**Glenview Public School
143 Townsend Avenue
Burlington, ON**

Structural Addendum No. 1

May 23, 2024

ROOF FRAMING PLAN
SCALE 1:100

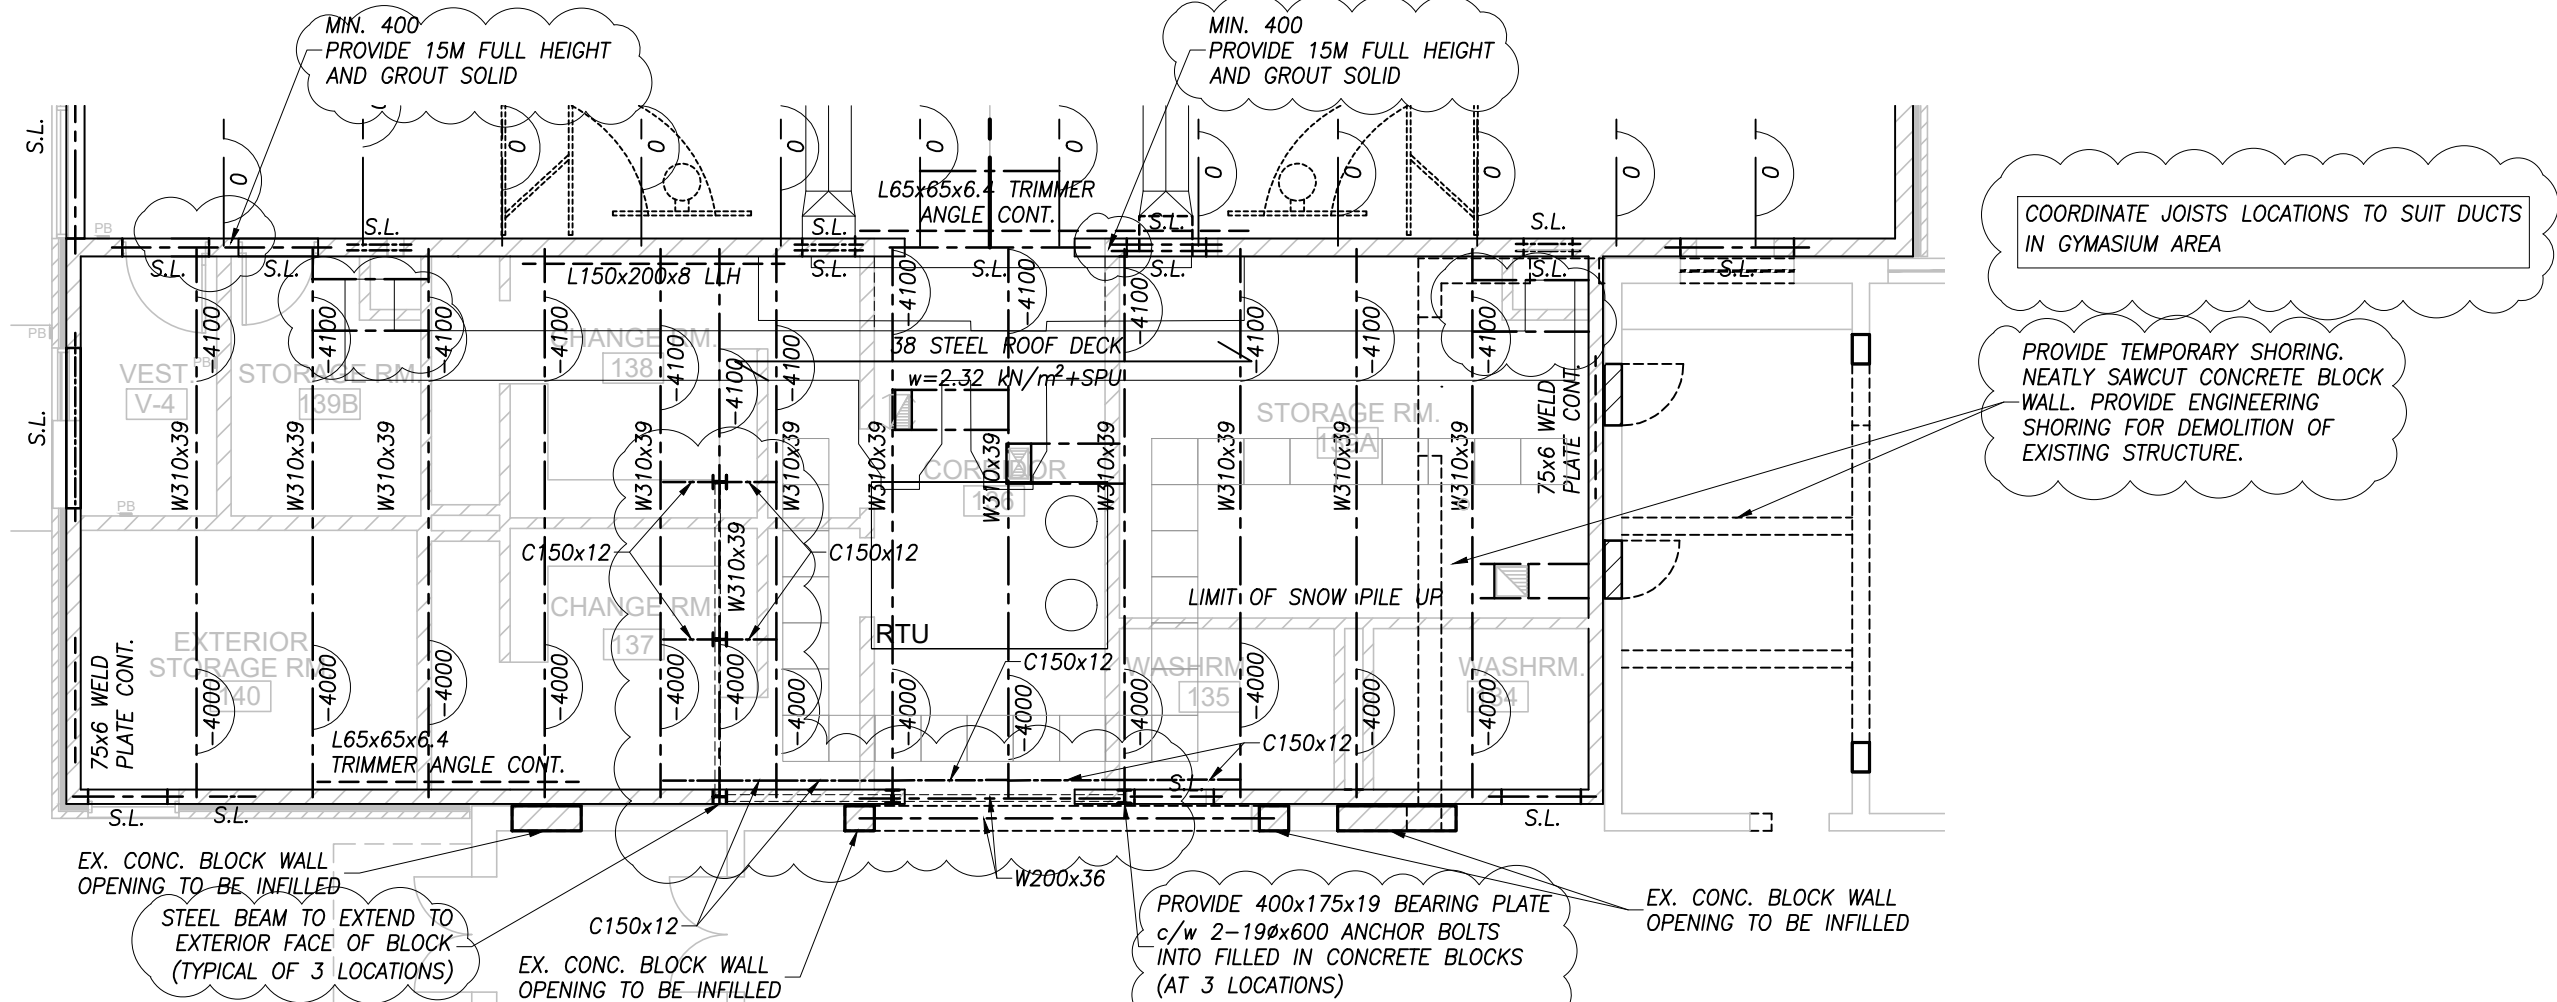
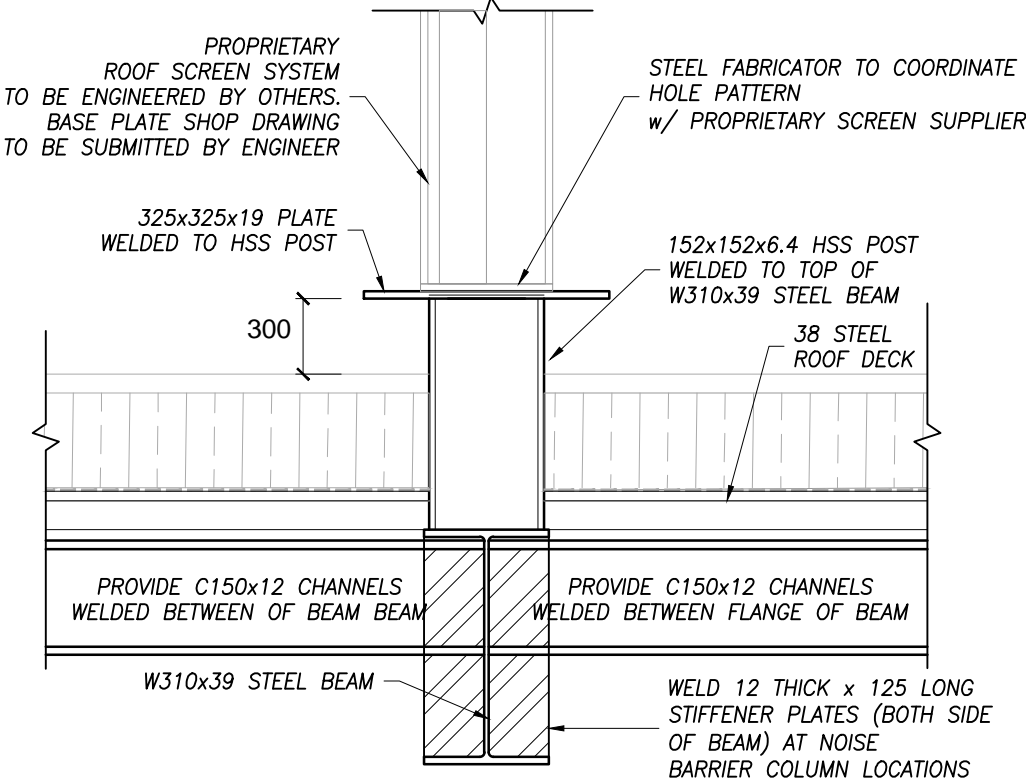
- a. Provide engineered shoring for the existing wall removals along GL E.
- b. Provide engineering shoring for the demolition of the existing structure at the Corridor/Kitchen/Washroom adjacent to the Staff Room. Neatly sawcut and isolate the structure to be demolished from the existing structure to remain. The structure to be demolished shall be full removed including foundations.
- c. Revise girt to support curtain wall along GL A between 1 & 6 from W200x27 to W200x150x7.9.
- d. Revise the three S.L.'s, one along GL 1 between A & B, one along GL A between 1 & 6 and one along 6 between A & B to S.L. 1. Refer to SK-S1.
- e. Provide additional 2-20M full height grouted solid along GL A between 1 & 6 adjacent to each high window opening.

- f. Provide minimum 400 concrete block reinforced with 2-20M grouted solid adjacent to door 139B and 139A.
- g. OWSJ supplier to coordinate duct locations with web members to accommodate the duct within the depth of the joist.

- h. Provide typical framing for RTU support and all opening in roof deck per the Typical Roof Top HVAC Unit Framing detail on S1.2.
- i. Provide supplemental structure to support roof screen. Provide additional W310x39 to support roof screen. Extend bearing on 3 – W310x39 to exterior face of wall complete with 400x175x19 bearing plate with 19 diameter x 600 long bolts. Provide C150x12 blocking between W310x39 at post locations. Provide 5 stub posts HSS152x152x6.4 complete with 325x325x19 cap plate (coordinate hole pattern with roof screen supplier) welded to top of W310x39. Provide 2-12x125 stiffeners in W310 at post locations. Provide engineered roof screen system complete with shop drawings to mount to stub columns.

S.L. -1
SCALE 1:10

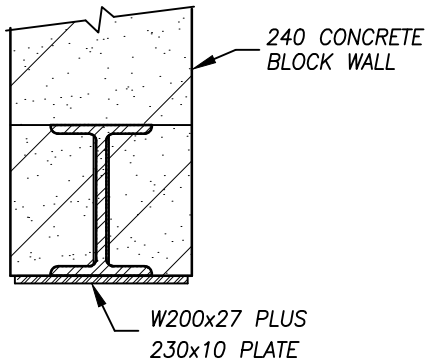
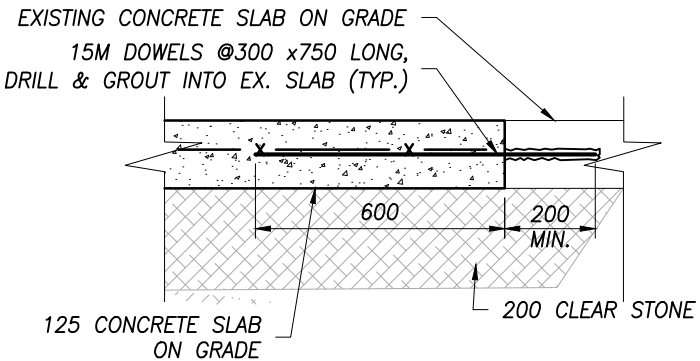
- a. Remove and replace existing concrete slab on grade to suit new plumbing connection in existing corridor adjacent to Staff Room. Refer to slab on grade repair detail on SK-S1.
